CABINET MEMBER FOR ENVIRONMENT – 11 JANUARY 2018

A4130 AT MILTON – PROPOSED TOUCAN CROSSING AND EXTENSION OF 40MPH SPEED LIMIT

Report by Director for Infrastructure Delivery

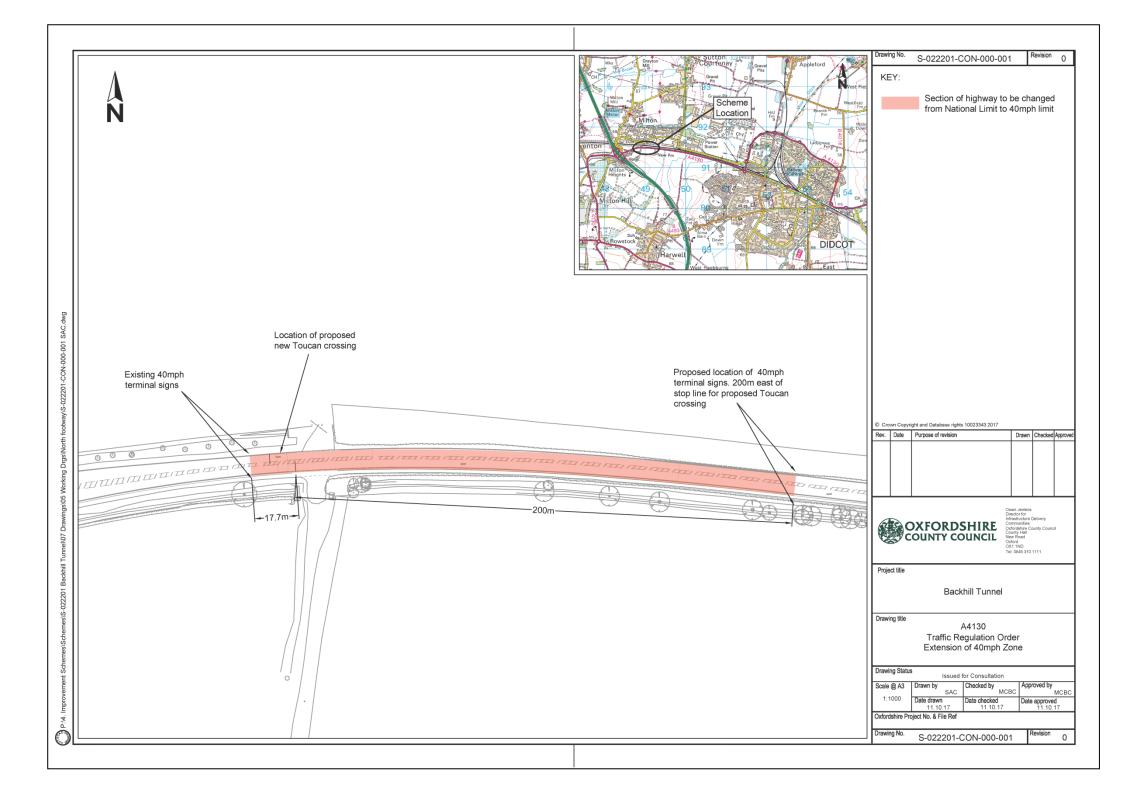
- 4. Four responses were received, comprising an objection from Thames Valley Police that the current speeds were too high and could compromise the safety of the crossing. Responses from Didcot Town Council, Milton Parish Council and The Vale of White Horse District Council expressed no objections to the proposal. However, Didcot Town Council's response did raise a concern that the proposed crossing was close to the existing traffic signalled junction to the west and also that the proposal was possibly premature. These responses are summarised at Annex 2 with copies of the full responses available for inspection by County Councillors.

- 6. Didcot Town Council's comment on the proximity of the proposed crossing to the traffic signalled junction to the west is noted. While it is accepted that the crossing is quite close (approximately 230 metres) to the latter junction, the separation is nevertheless considered acceptable, noting also that an independent safety audit of the crossing will be carried out. In respect of their comment that the project is premature, the crossing is being provided as part of a wider project to provide a safe route for pedestrians and cyclists to Milton Park, including the recently opened Backhill Tunnel cycle and pedestrian link.

RESPONDENT	SUMMARISED COMMENTS
(1) Milton Parish Council	No objection – No comment.
(2) Didcot Town Council	No objection - Welcomes the prospect of increased pedestrian access to Milton Park. However, there are concerns over the location of the proposed crossing's proximity to existing lights and other proposed crossings and the cumulative impact these crossings will have on traffic flow. We feel that the proposal may be premature at this point in time.

(3) Traffic Management Officer (Thames Valley Police)	Object - After careful consideration of the documents and speed data provided, I object to these proposals. Existing speeds are clearly too high and this could compromise safety on the crossing point. Extending the current 40mph speed limit by 200m I also feel is excessive without other measures to slow speeds.

- 5. The objection of Thames Valley Police is noted. A speed survey carried out in the vicinity of the crossing shows average speeds to be 45mph eastbound and 46mph westbound and it is anticipated that with the proposed 40mph speed limit in place, speeds would reduce by approximately 3mph, bringing the speeds here to a level consistent with those observed in other 40mph speed limits. It is also considered that the proposed speed limit is consistent with the Department for Transport guidance on setting local speed limits talking account of the character of the road. It should also be noted that signalled crossings of this type installed on roads subject to a 40mph speed limit operate with very good levels of safety.
